Staff Report

Applicant: De Beers Canada Inc. -Gahcho Kué Project	
Location: Kennady Lake, NT	Application: MV2005L2-0015
Date Prepared: July 11, 2016	Meeting Date: July 21, 2016
Subject: Dyke Construction and Management Plan for Water Collection Ponds (Version 1)

Review Comment Table

Re: De Beers Gahcho Kue
MV2005L2-0015
Water Collection Ponds Dyke Construction and Management Plan (Version 1)
Request for Comment

GAHCHO KUE PROJECT NT, CANADA			
CP7 AND CP8 LOCATIONS			
PROJ. FC# NO. E14103040-11-005	DWN HX	CKD WTH	REV 0
OFFICE EDM	DATE June 2016		Figure 1

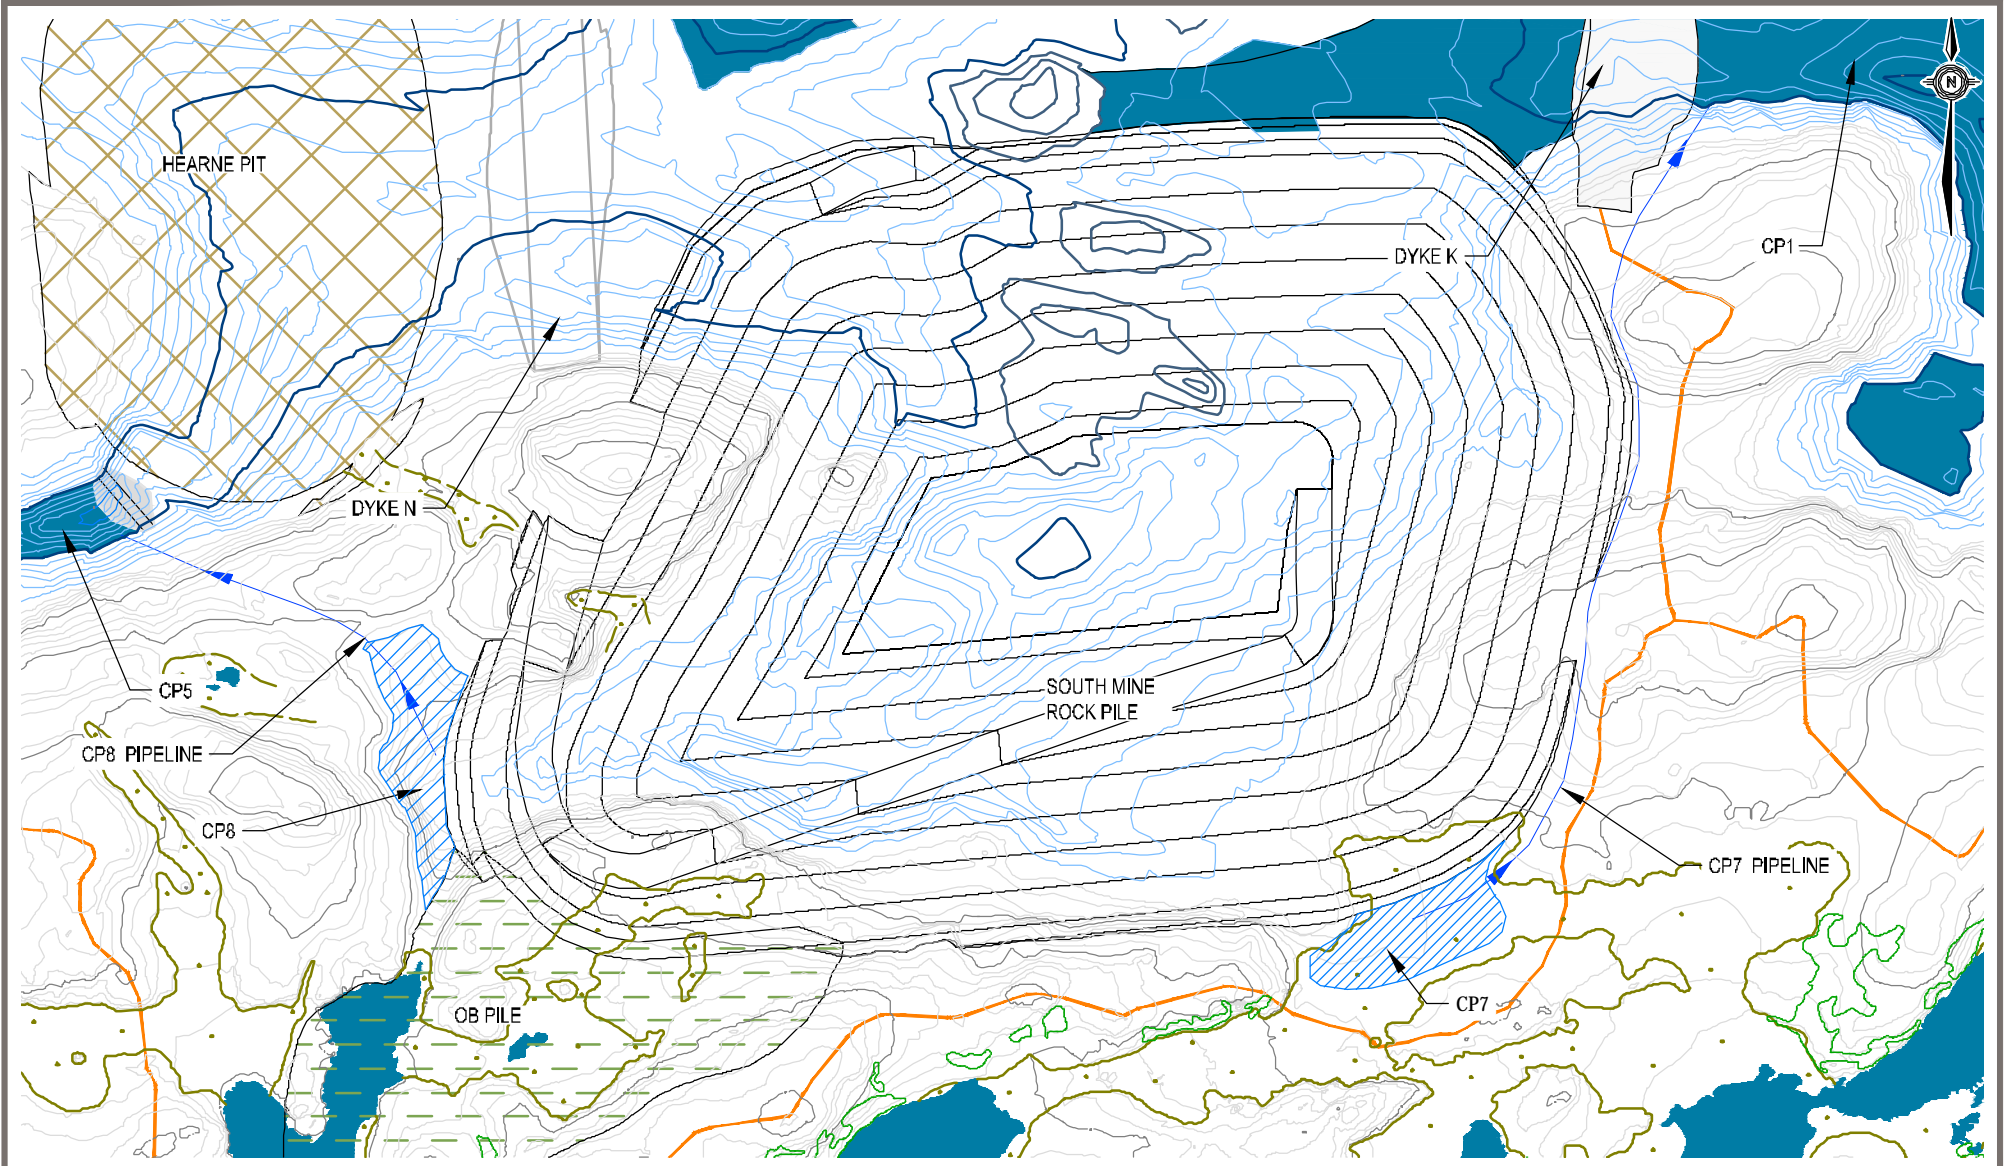
Collection Ponds 7 and 8 do not require the construction of dikes as they will be formed in the depression the lake bed. It is unclear from the figure if this is still within the bed of Kennady Lake or if these are individual depressions that are located south of the South Mine Rock Pile (SMRP). As they are south of the SMRP, these areas will be isolated from the Water Management Pond so it is unclear where the overflow from these areas will go.

ENR requests additional information on the locations of Collection Ponds 7 and 8. The information should describe their condition prior to development as well as their current condition.

ENR requests clarification on the flow pathway from overflow originating from Collection Ponds 7 and 8.

GNWT - ENR: Central Email GNWT				
ID	Topic	Reviewer Comment/Recommendation	Proponent Response	Board Response
1	General File	Comment (doc) ENR Comments Recommendation		N/A
2	Collection Ponds 7 and 8	Comment Collection Ponds 7 and 8 do not require the construction of dikes as they will be formed in the depression the lake bed. It is unclear from the figure if this is still within the bed of Kennady Lake or if these are individual depressions that are located south of the South Mine Rock Pile (SMRP). As they are south of the SMRP, these areas will be isolated from the Water Management Pond so it is unclear where the overflow from these areas will go. Recommendation ENR requests additional information on the locations of Collection Ponds 7 and 8. The information should describe their condition prior to development as well as their current condition. ENR requests clarification on the flow pathway from overflow originating from Collection Ponds 7 and 8.	June 30:  As shown in Figure 2, general site layout plan in the Management plan report and attached zoomed-in Figure 1, CP7 is located at southeast corner of the SMRP and CP8 is located at west corner of the SMRP. CP7 and CP8 will be formed after the construction of the SMRP. CP7 is located within a marsh area. CP8 is just out of boundary of the lakebed, it is in an isolated depression with a local hill. The geological unit in this area is till veneer. As described in Section 3.7, the water collected in CP7 will be pumped to Area 7 (CP1) or other designated storage area. The water collected in CP8 will be pumped to CP5 or other designated storage area.	Additional clarification sought from De Beers on July 8, 2016. The additional information submitted on July 13, 2016 should be added to the plan.
